ADDENDUM NO.1

Request for Proposal No. 18 358

Roof Replacement for Frank West Hall & Cliff Mahlman Fire Hall

Date: January 17, 2018

IRC #:	19652	NORTH:
W.O.#:	VR17-077SP	
SCALE:	1" = 10'	DWG.#: R1(REV.1)
DATE:	JULY/2018	
DRN. BY:	B.W.	
CHK. BY:	M.K./D.W.

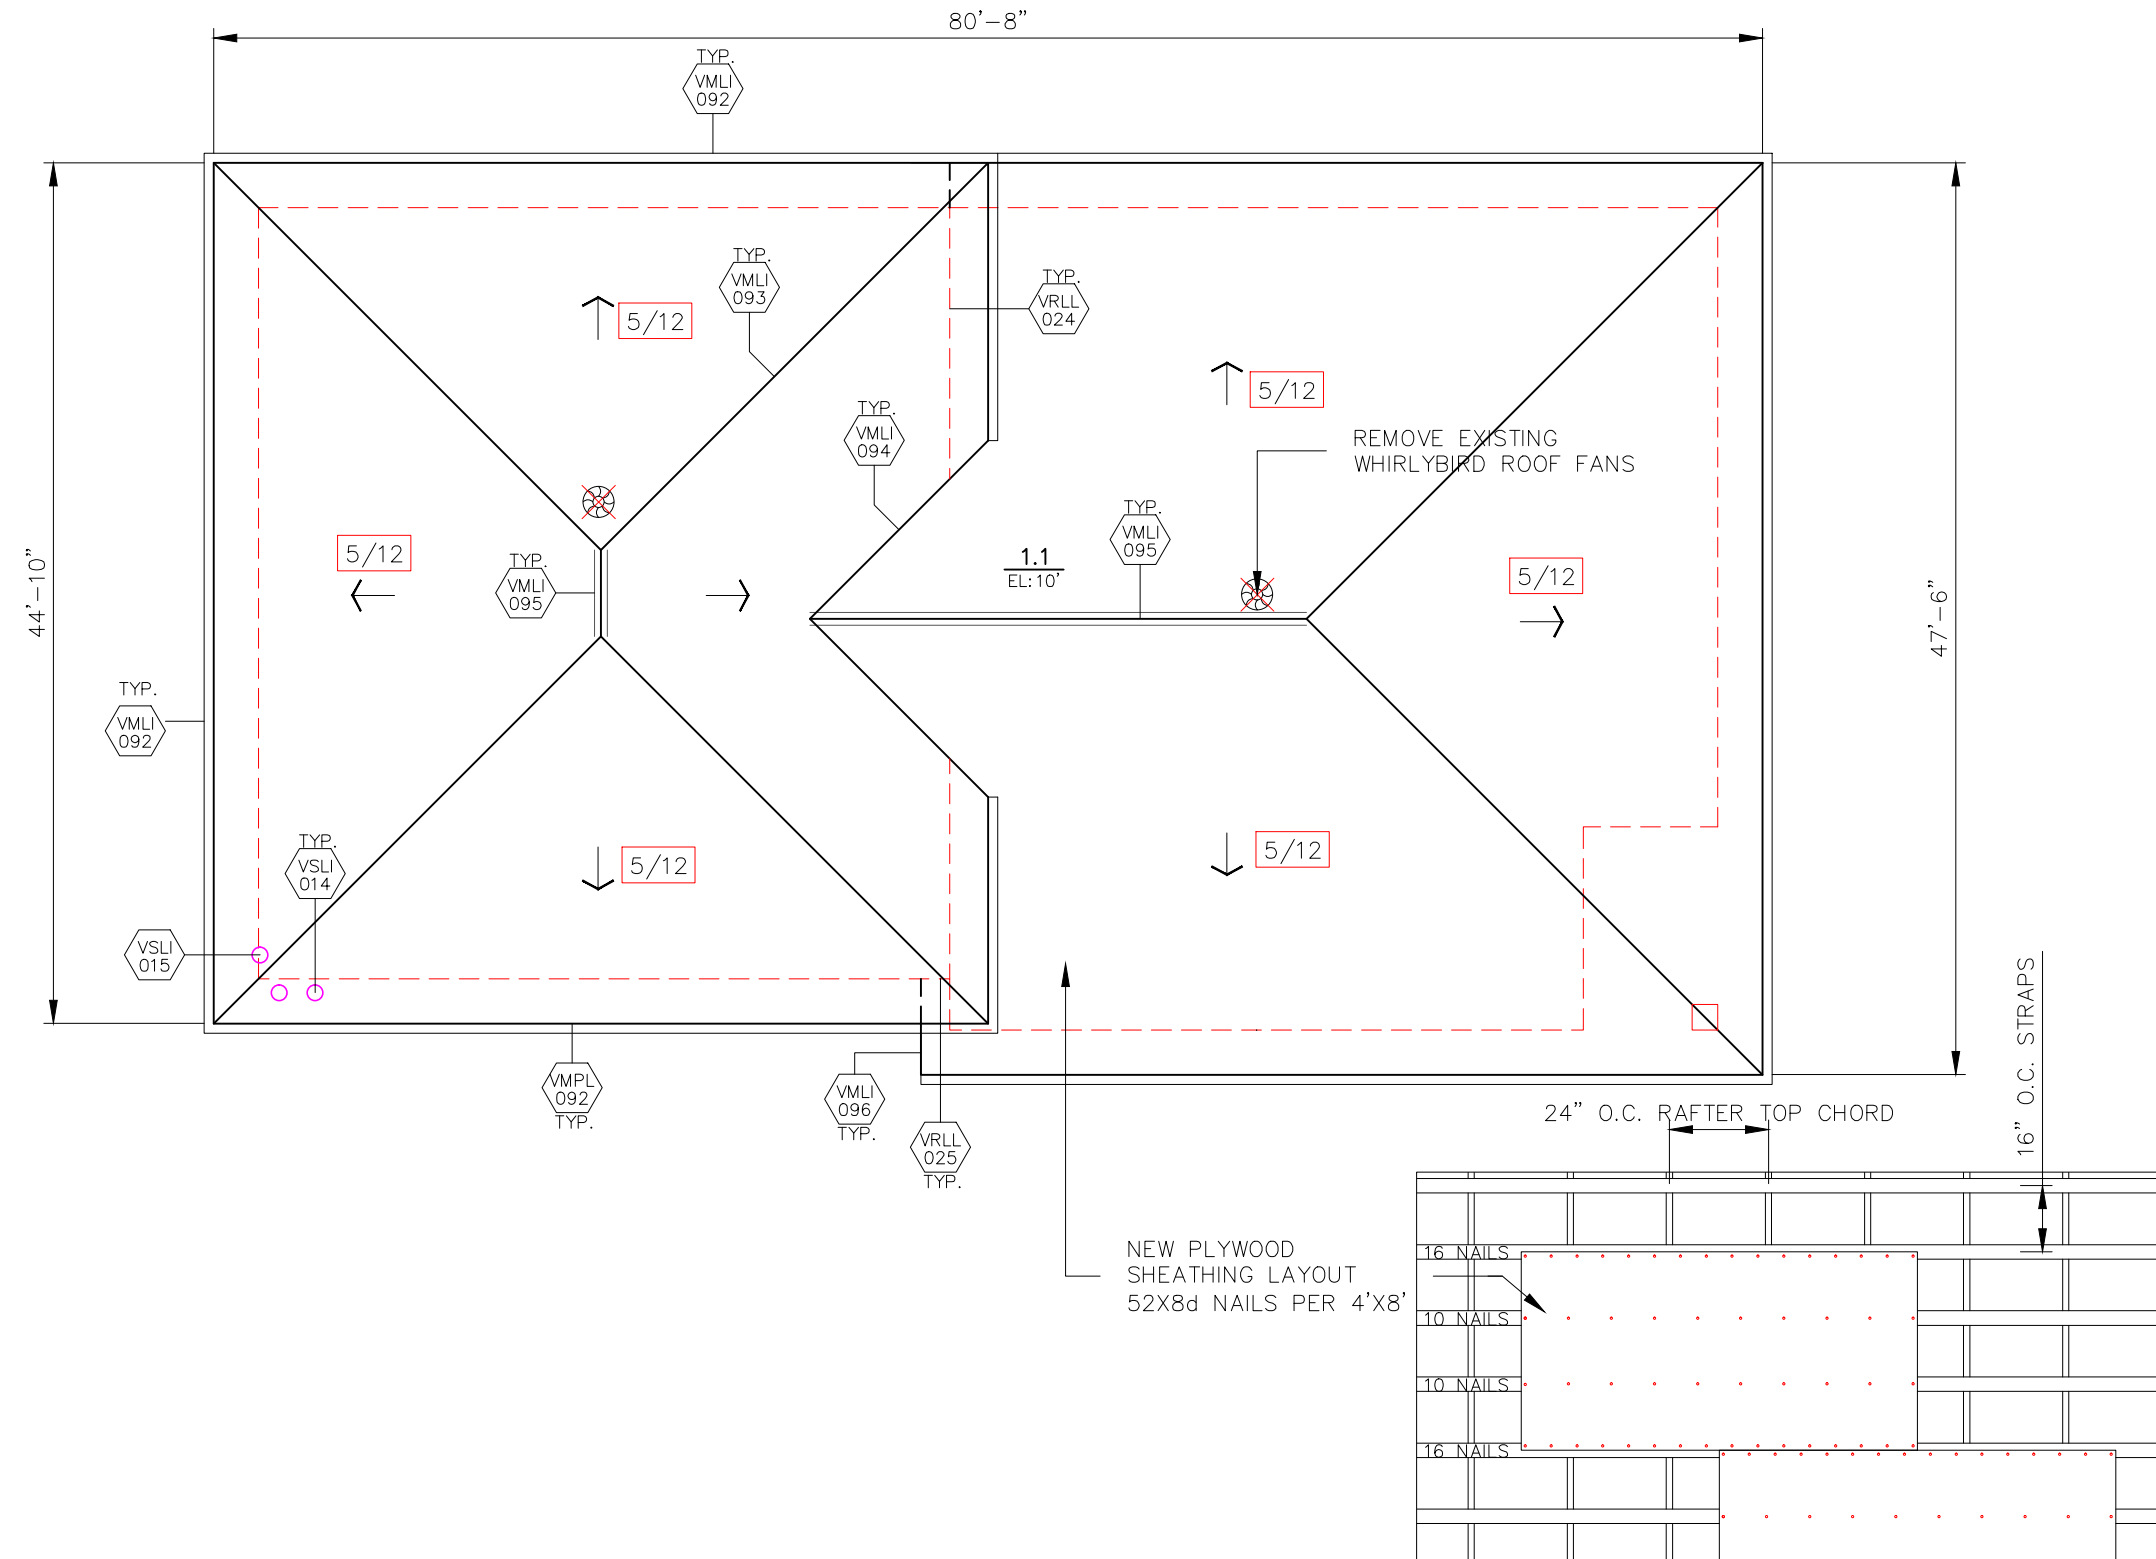
Delete: Roof Plan Drawing R-1 and replace with attached roof plan R-1 Revised.
